Addendum No. C

To the contract documents for NORTH VERDEMONT ELEMENTARY SCHOOL, DSA No. 04-122168

For the SAN BERNARDINO CITY SCHOOL DISTRICT

LPA Project No.: 30899

FOUNDATION and ROOF FRAMING PLANS

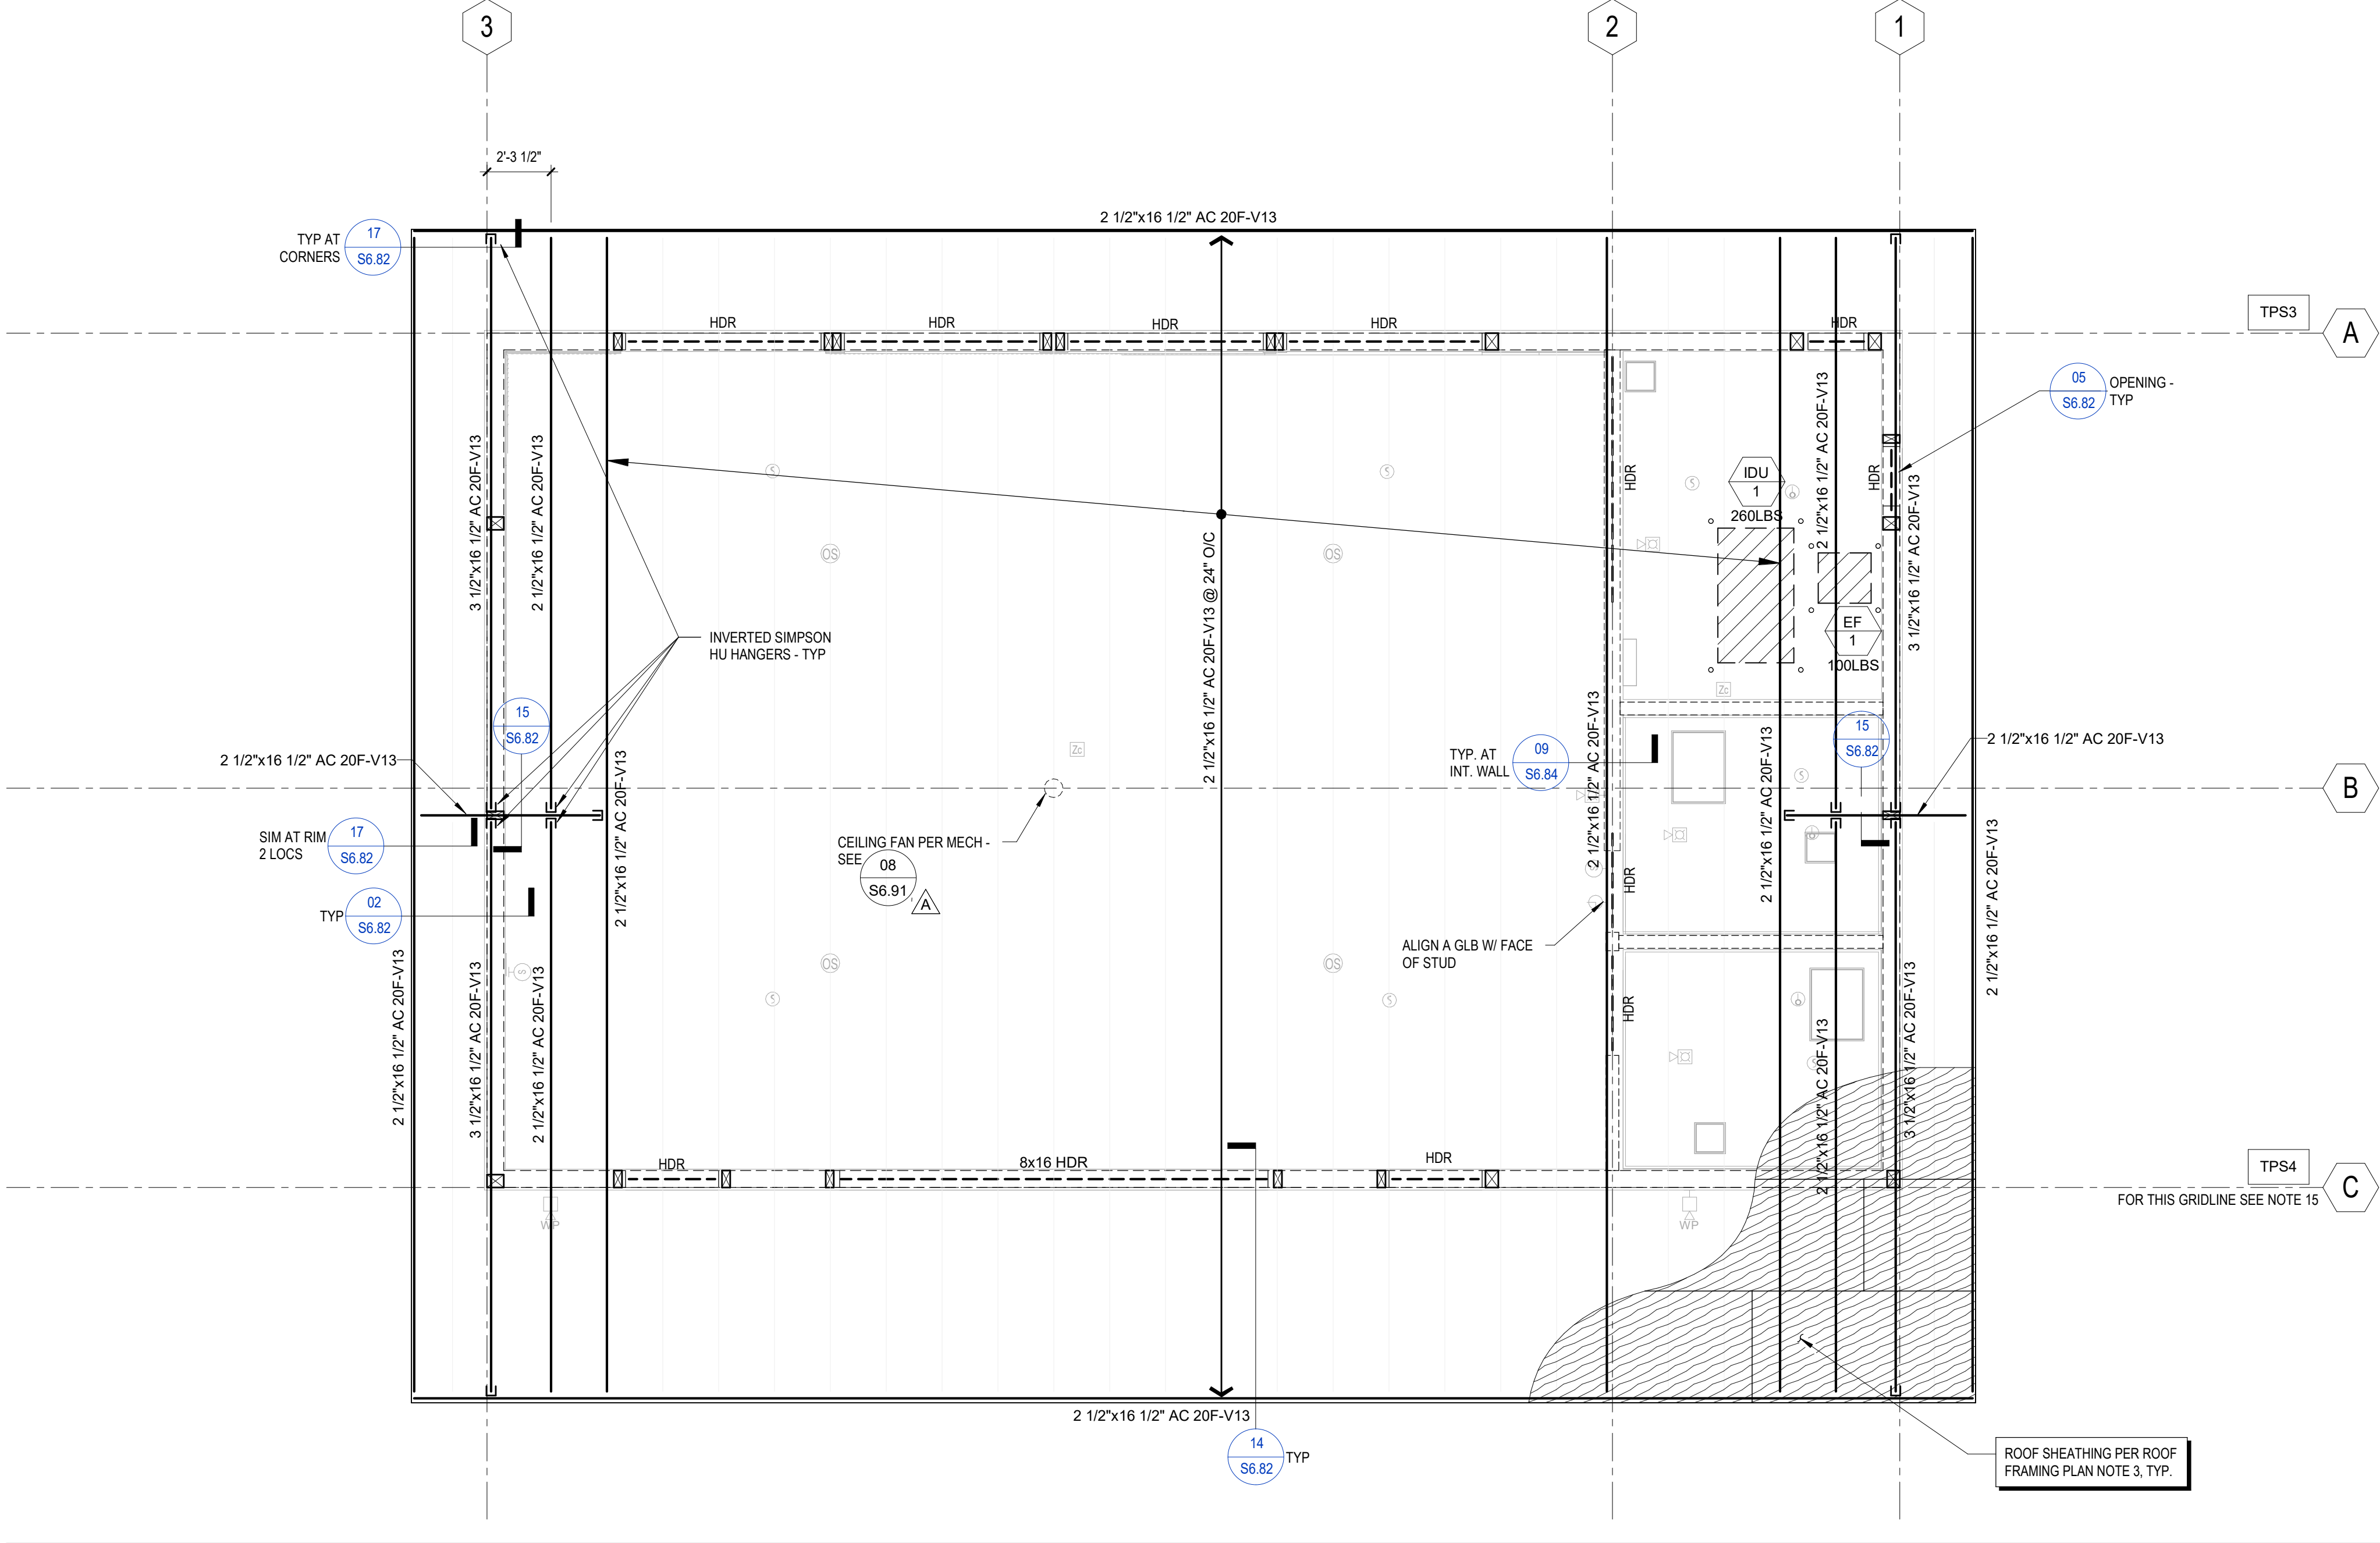
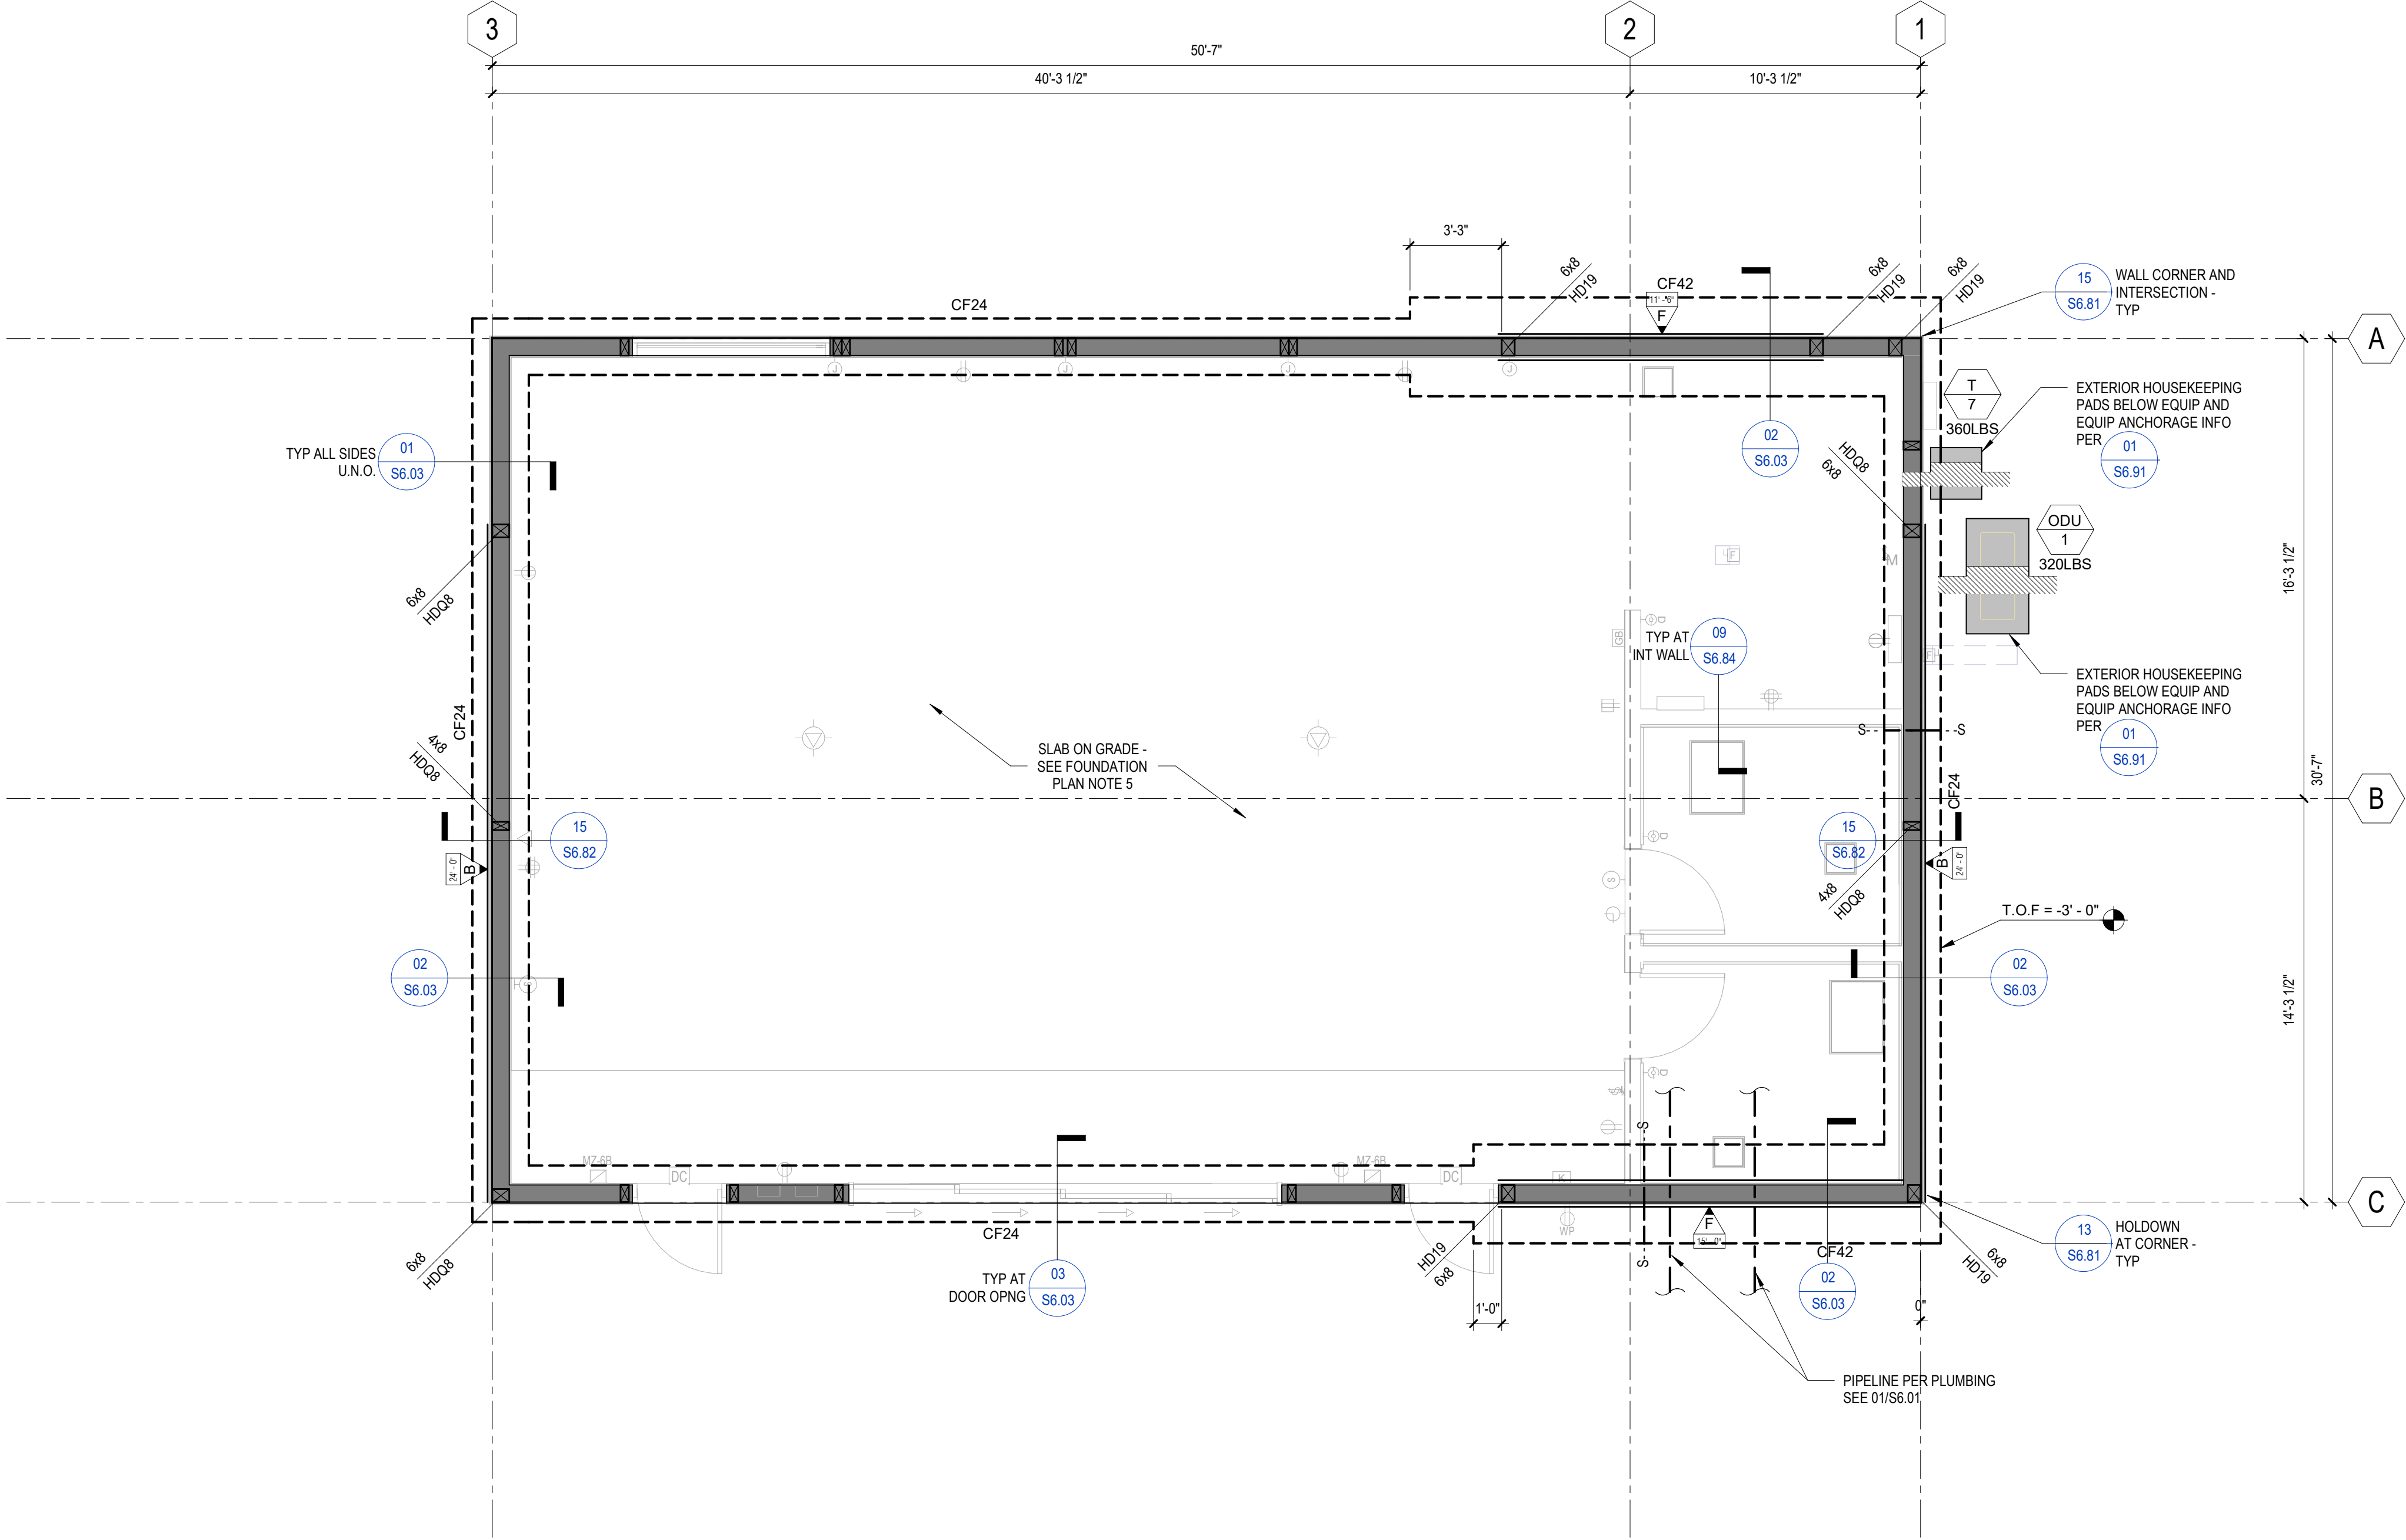
| <b>Item No. 5</b> | S2.01 – FOUNDATION AND ROOF FRAMING PLANS<br>a) Revised Foundation Plan note 5.  |

- Item No. 13** Please see Foundation Note #5 on sheet S2.01 which mentions "properly prepared soil as described in geotechnical report." No geotechnical report has been provided in the bid documents. Please provide a geotechnical report.

- Response: Foundation plan note #5 has been revised and reference to geotechnical report has been removed, since there is no geotechnical report for this project. Refer to addendum C drawings.
